April 15, 2008 Planning Commission Staff Report, Adopted Resolution 2008-21 Denying the requested entitlements, and Meeting Minutes

MEETING OF APRIL 15, 2008

Application I.D.: 2006-0054

Application Type: Tentative Parcel Map and Single Family Design Review

CROSS SECTIONS
ADAMS RESIDENCE
BELMONT, CALIFORNIA

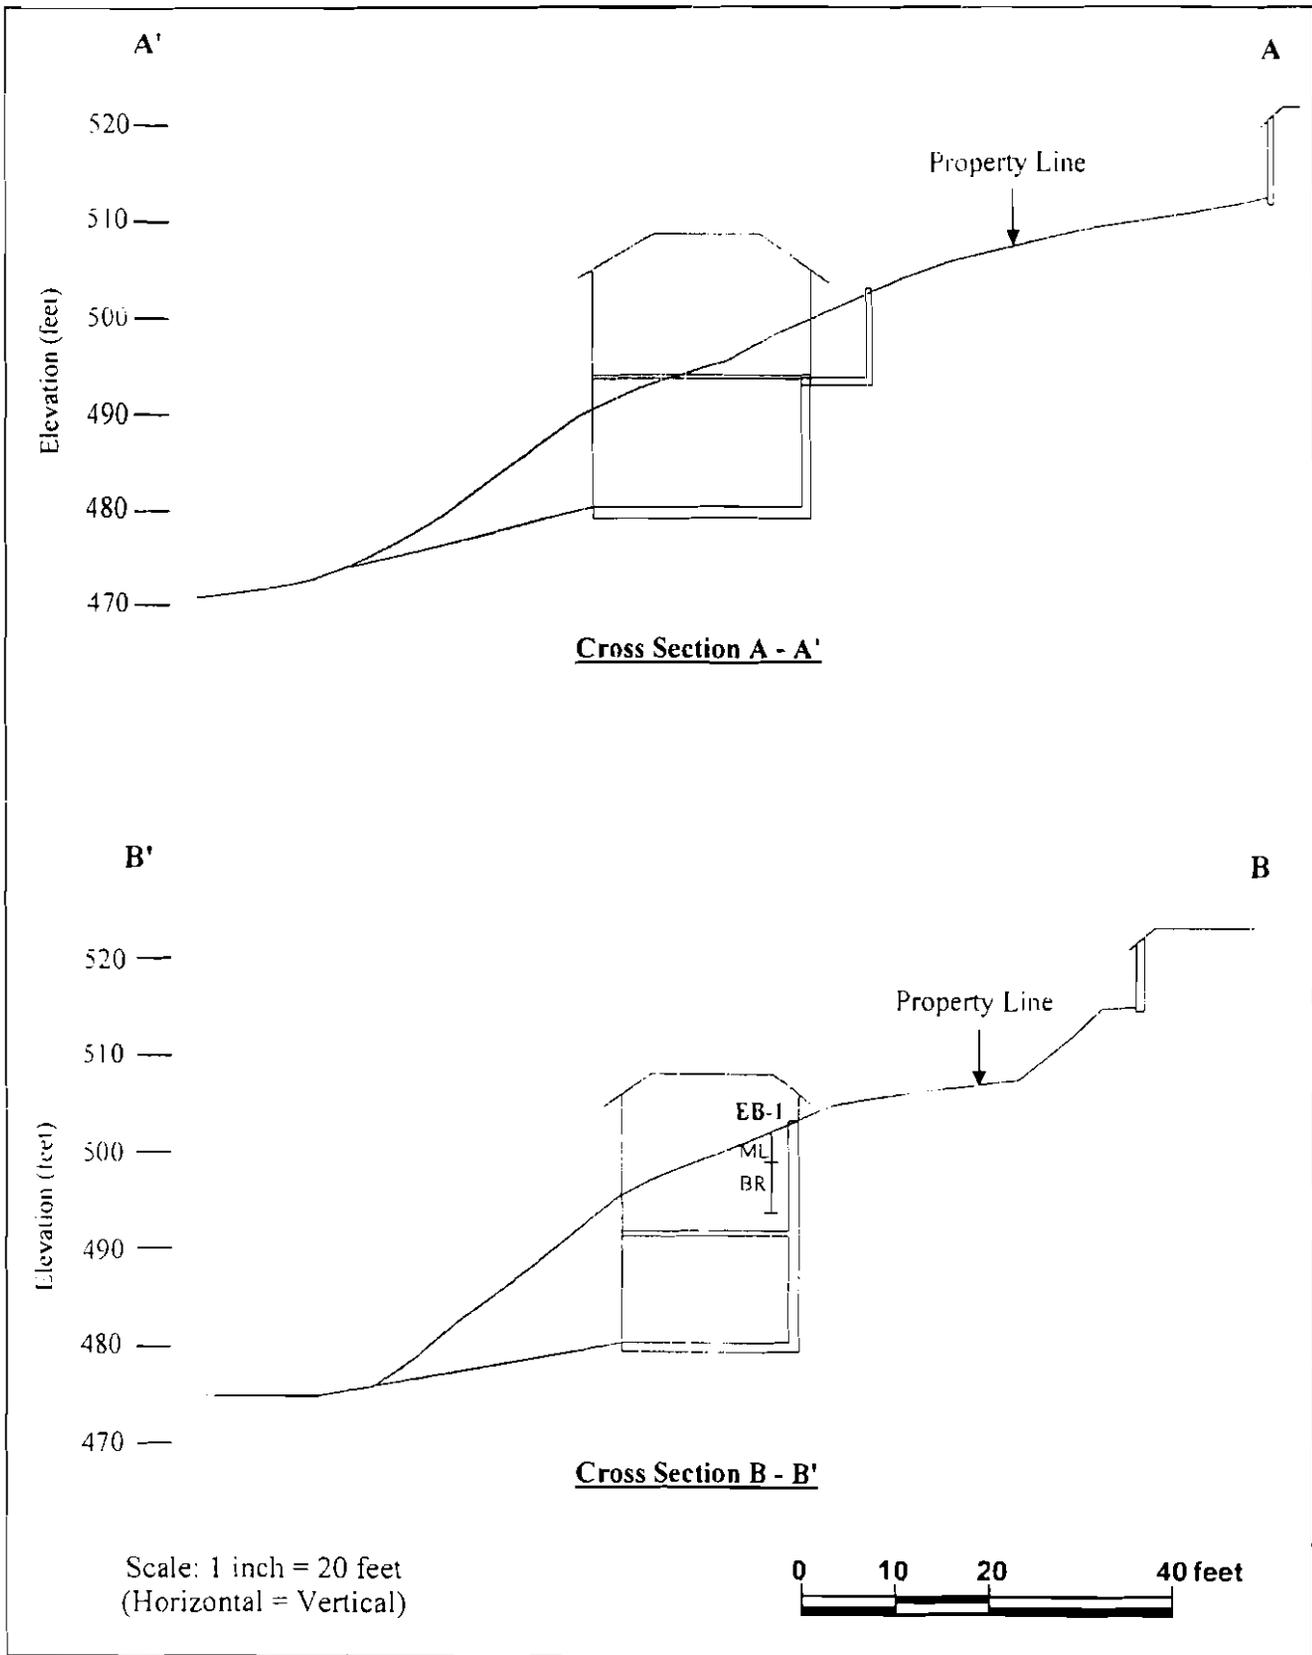
We reviewed comments in the letter from Cotton, Shires & Associates, Inc., dated December 15, 2006. We also reviewed the tentative parcel map (dated September 2005, prepared by Smith Randlett Foulk & Stock, Inc.) and architectural plan sheets 1, 2, and 3 (dated July 25, 2005, prepared by Robert W. Hayes, Architects). The Cotton letter requests discussion and evaluation of the stability of temporary construction excavations required for the planned residence.

With respect to the review comment from Cotton, Shires & Associates, Inc. we have prepared two cross sections showing the height and location of the required cuts relative to the property line and upslope residence located at 1109 Alomar Way. The location of the planned residence and cross sections are presented in Figure 1 attached while the cross sections are presented in Figure 2. We note that the back wall of the planned retaining walls and residence basement walls are located as close as about 18 feet from the property line, and the cut is about 25 feet high at this location in what appears to be the most critical location.
